Nomad

ALERT SERVICE BULLETIN

EXHAUST - NOZZLE HALF CLAMP INSPECTION/MODIFICATION

Figure 1 Exhaust Nozzle Clamp Installation

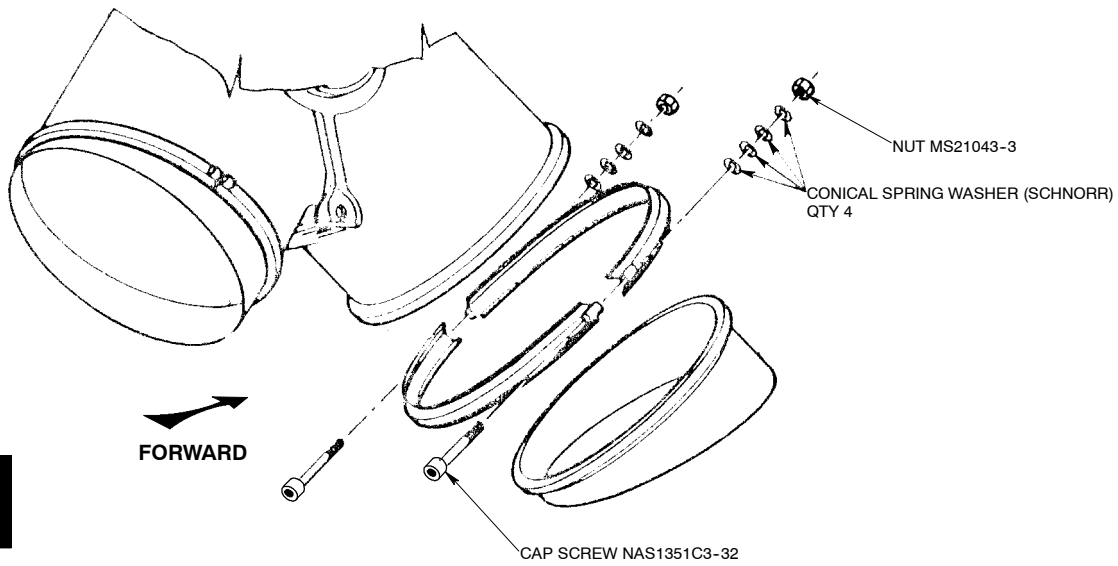
- (1) Open lower cowl.
- (2) Refer to Fig 1 and remove the exhaust stub nozzle half-clamps and stub nozzles from the engine.
- (3) Discard existing bolts, nuts and plain washers, retain conical spring washers.

Figure 2 Clamp and Rework

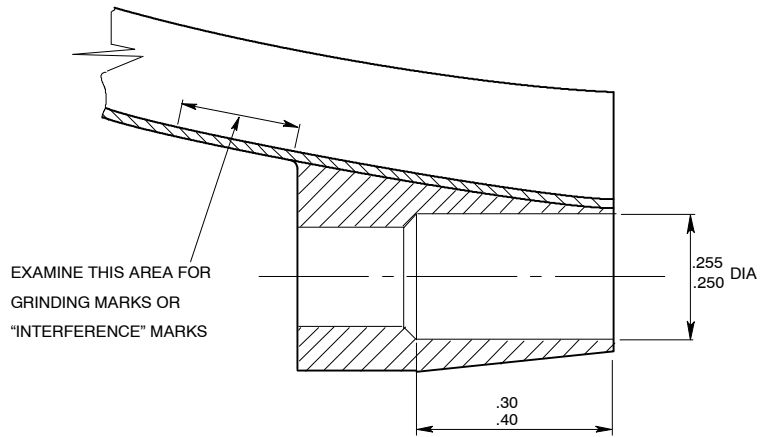
- (4) Dye penetrant inspect each half-clamp PN 1/N-50-548 in the vicinity of the welds for evidence of cracking. Any cracking is cause for rejection. Examine welds and the area shown on Fig 2 for evidence of grinding and/or "interference" marks. Any grinding marks which result in a loss of clamp thickness are a cause for rejection, other marks may be dressed using a round needle file to remove burrs and sharp corners.

- (b) Insert a clamp bolt through each bolt hole. Bolts should pass through the bolt hole without interference.
 - (c) If the bolt will not pass through the bolt hole and there is obvious distortion of the half-clamp ends, reject the half-clamp/s. If the bolt will not pass through the bolthole and there is NO obvious distortion of the half-clamp ends, turn a half-clamp 180° and re-check. If it will still not pass through, counterbore the half-clamp ends per Fig 2 and re-check.
Reject if the bolt will still not pass through.

Figure 3 Conical Washer Installation

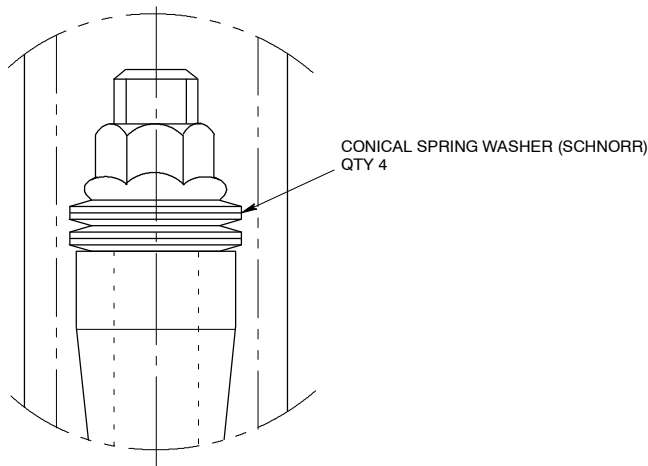
- (6) Refit Exhaust Stub Nozzle and Clamp Ring Halves to the aircraft in reverse order to their removal, observing the correct assembly of the bolt, nut and conical spring washers, including the additional pair, as per Fig 3. Use anti-seize compound on bolt threads.
- (7) Tighten the clamp attachment nuts until the conical washers are bottomed-out, as indicated by a noticeable increase in torque. Back-off each nut from this point by one turn.
- (8) Refit the lower engine cowl.
